Subject: AP1000 COL Response to Request for Additional Information (TR 36)

Response to Request for Additional Information on Technical Report No. 36

RAI Response Number: RAI-TR36-012

Figure 3-1  
Complete Loss of Forced Reactor Coolant Flow

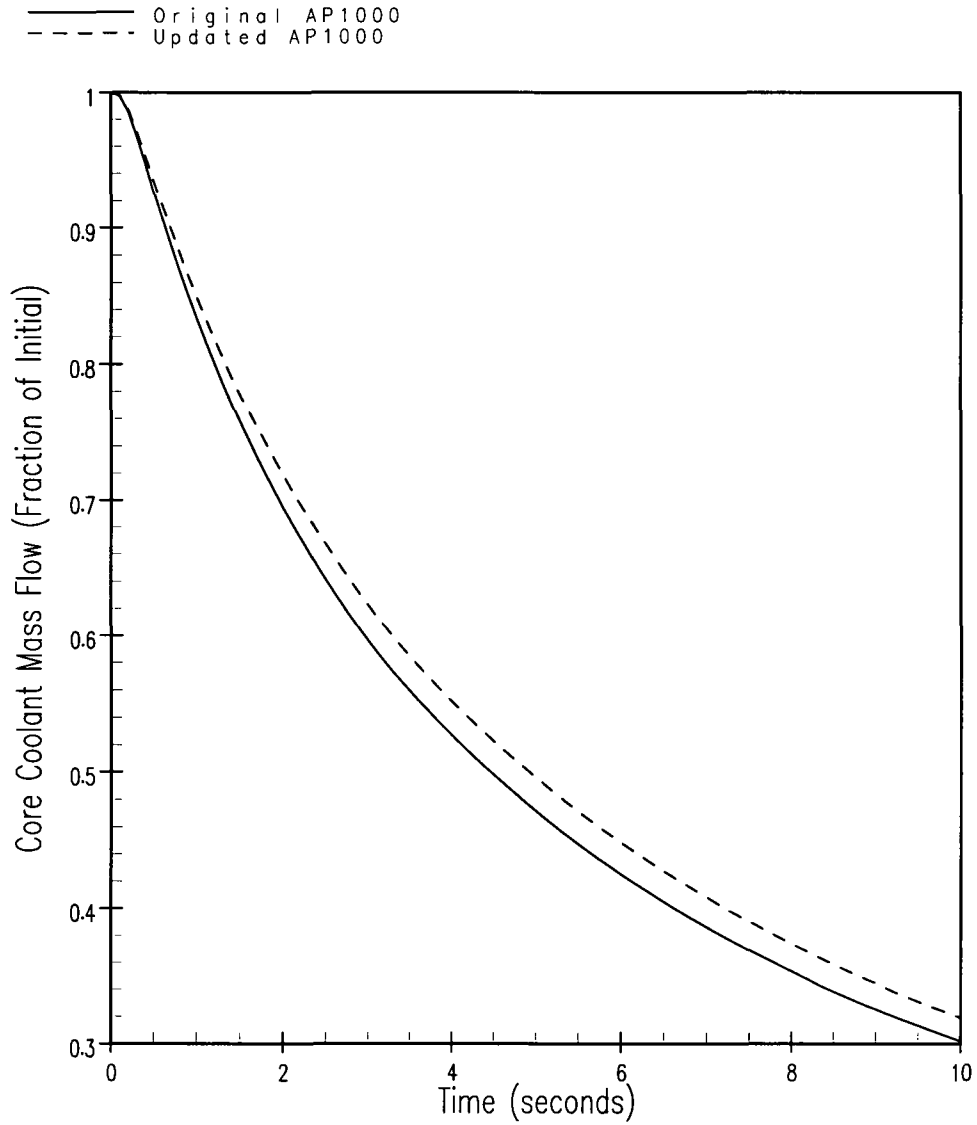
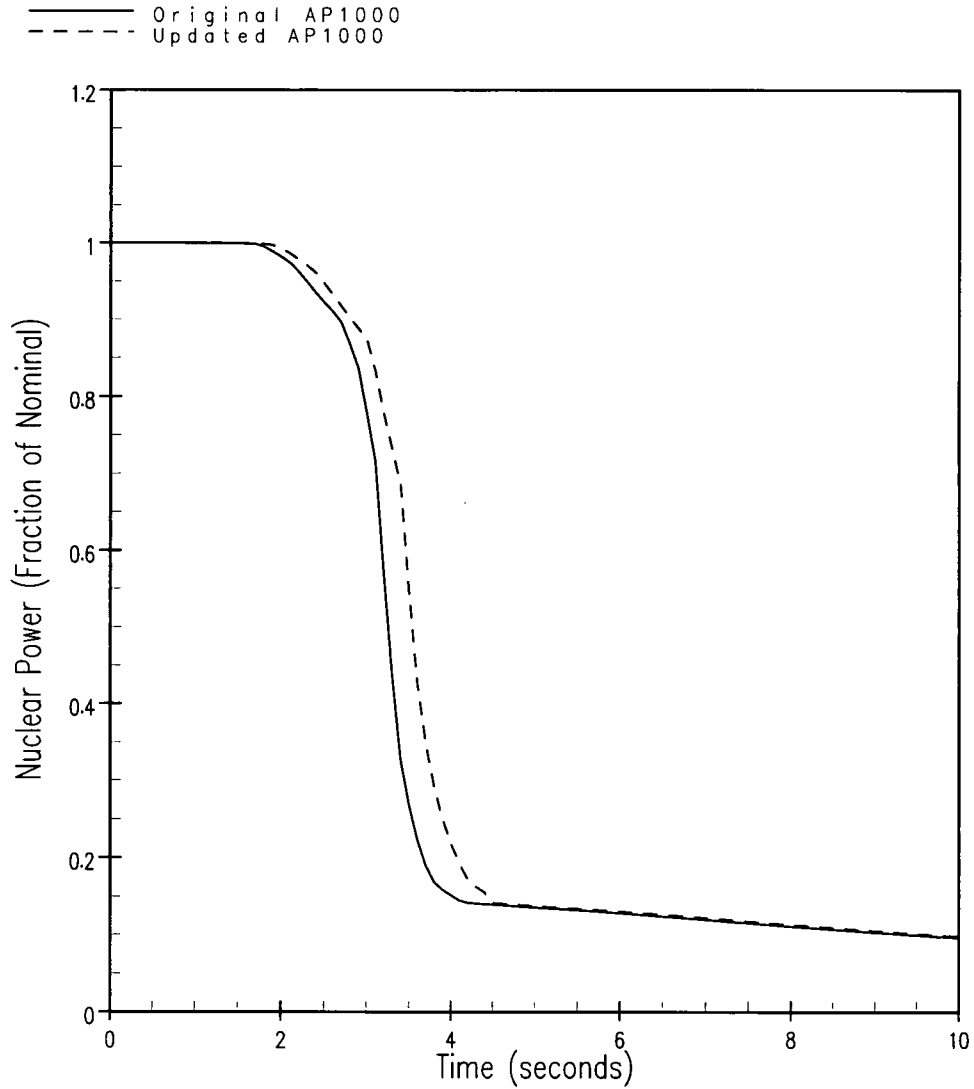
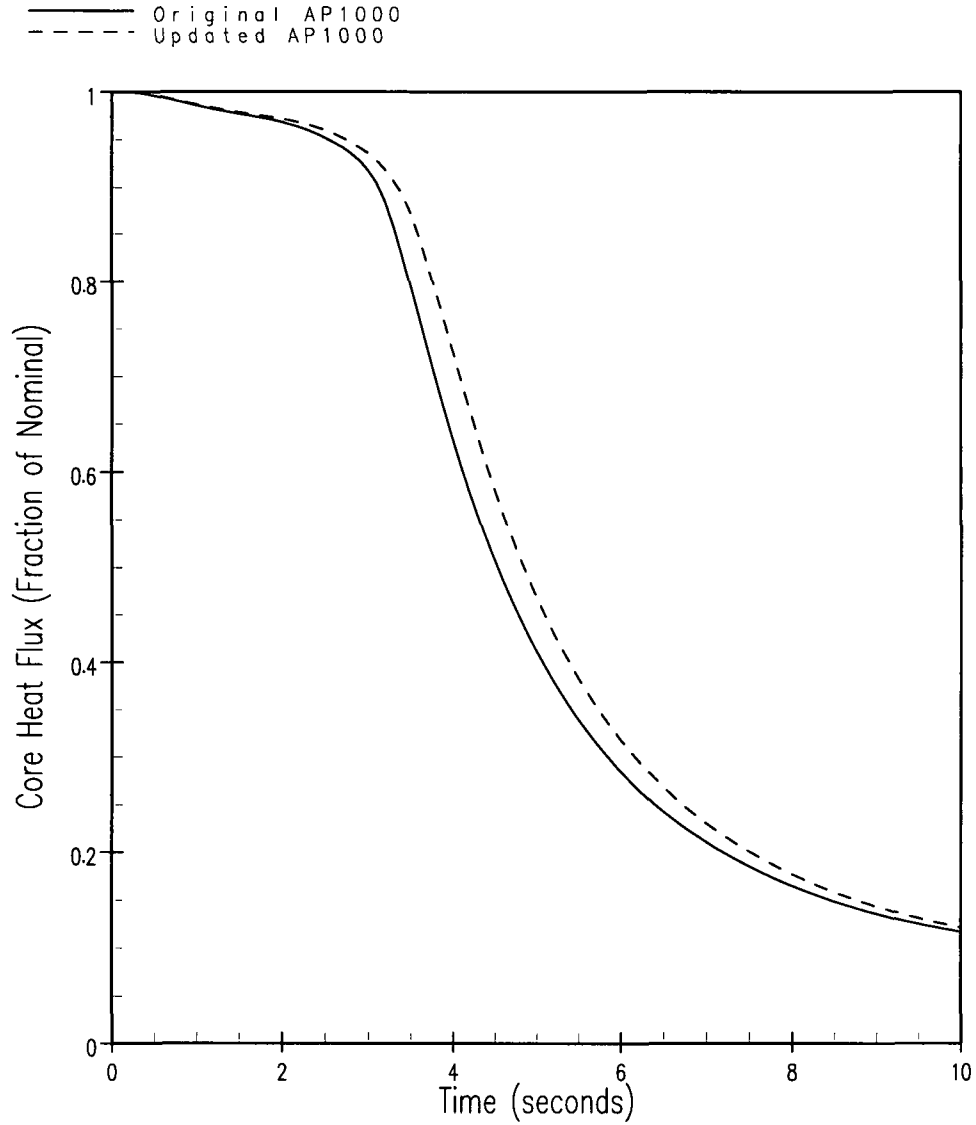
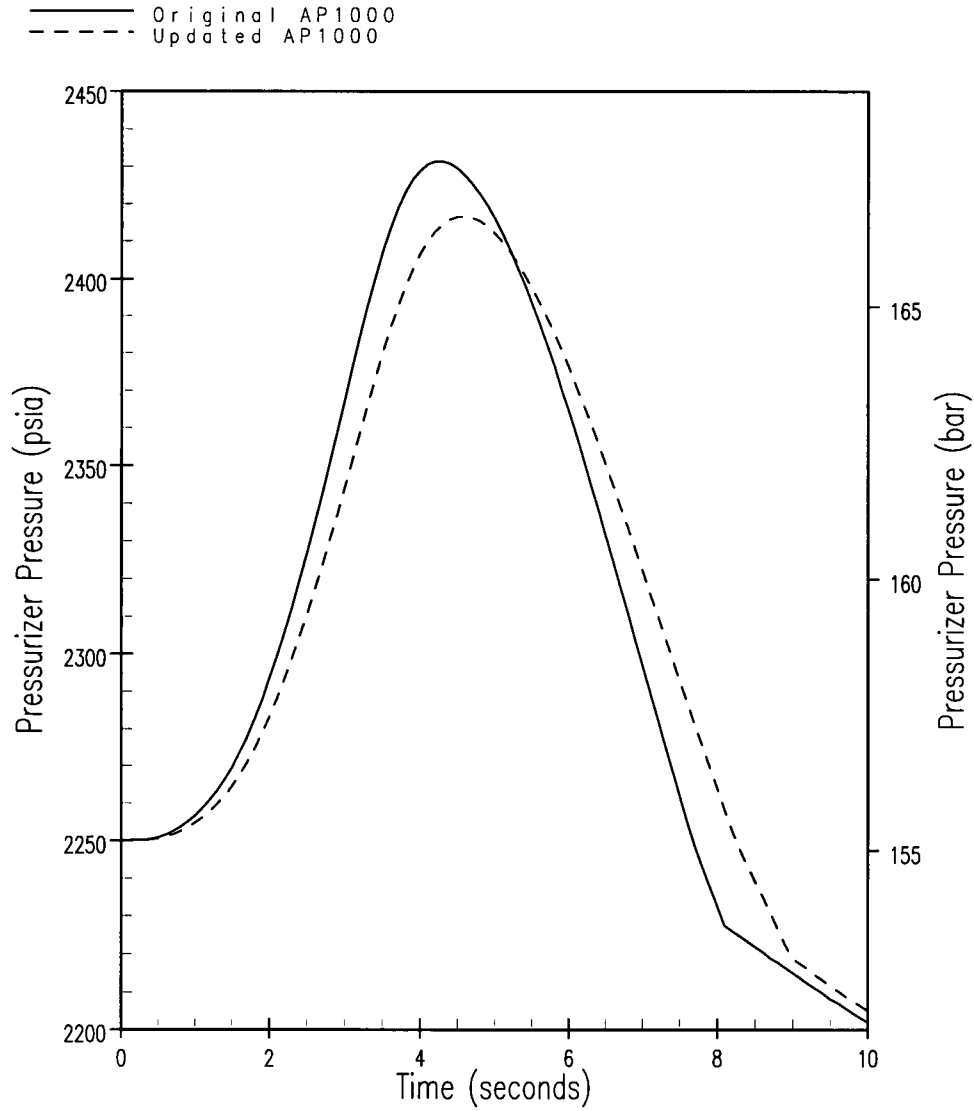
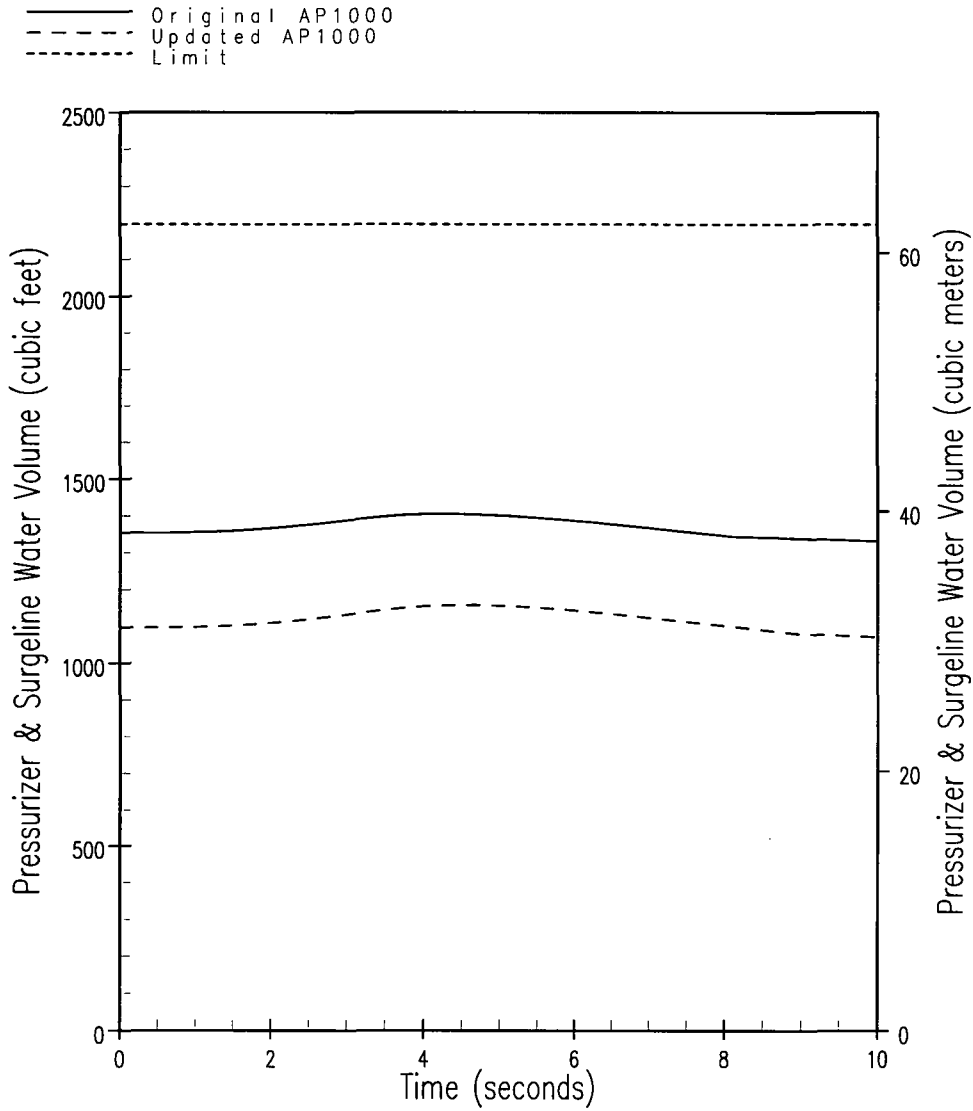
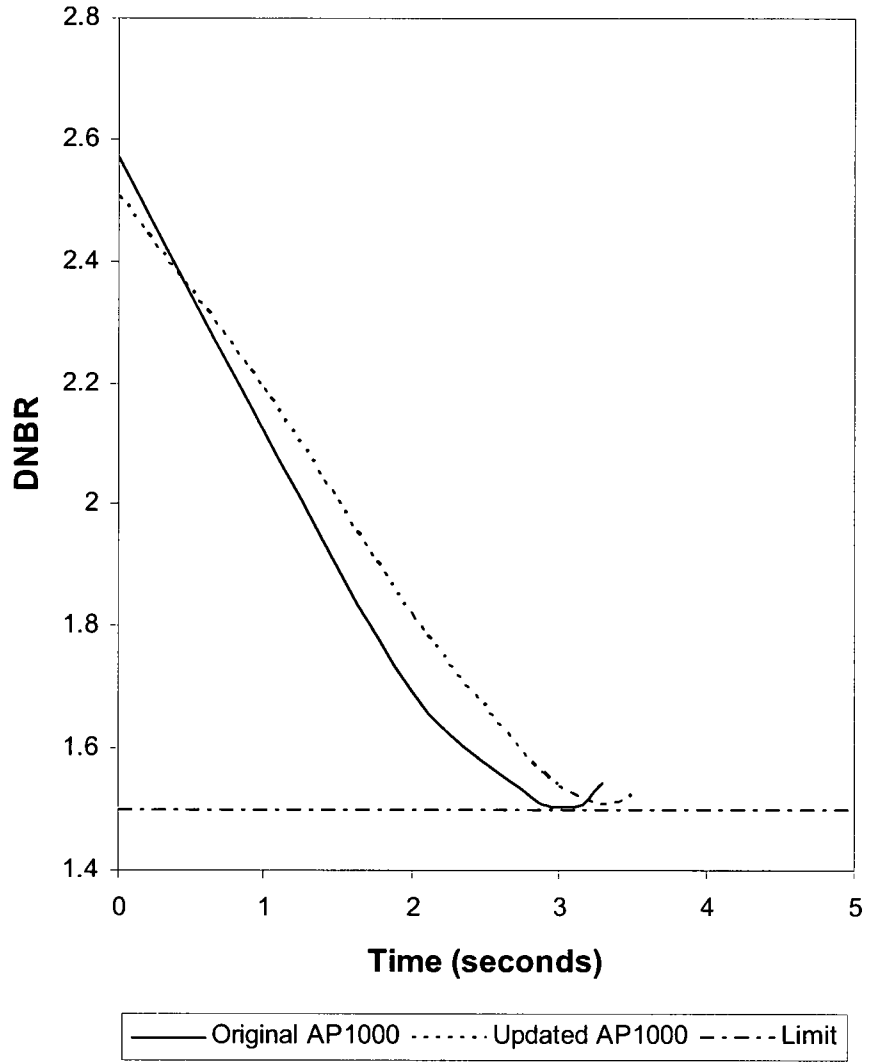
The pressurizer changes affect many parameters such as the cross-sectional area of the pressurizer, pressurizer vessel height, initial pressurizer water level, pressurizer setpoints, ADS stages 1, 2, and 3 elevation and pressurizer heater length. We are concerned about the combined effects of the values changed for the above parameters on the thermal hydraulic response during transient and accident conditions. We determined that the qualitative statement in the RAI response is not sufficient to resolve the RAI issue. We request Westinghouse perform the quantitative analyses for the limiting event for each of the following Standard Review Plan chapter 15 event categories:

Results from the analysis for the updated AP1000 configuration are shown in Figures 3-1 through 3-7. A sequence of events for the analysis is summarized in Table 3-1. Also included with these results are analysis results for the AP1000 configuration in Revision 15 of the DCD.

With the updated AP1000 configuration, the results have improved slightly. This is principally due to a slight increase in the reactor coolant pump inertia when compared to the previous DCD analysis. The increased inertia, which is consistent with the AP1000 ITAACs, results in a slightly slower reactor coolant pump coast down (see Figure 3-1). With a slower reactor coolant pump coast down, the time of reactor trip is delayed slightly. However at the time of minimum DNBR, reactor coolant flow is slightly higher and minimum DNBR is higher. The DNBR safety analysis limit is 1.5. The original AP1000 configuration had a minimum DNBR of 1.505 for the complete loss of flow. The updated AP1000 configuration results in a minimum DNBR of 1.510. The existing complete loss of reactor coolant flow analysis is bounding for the current AP1000 configuration.
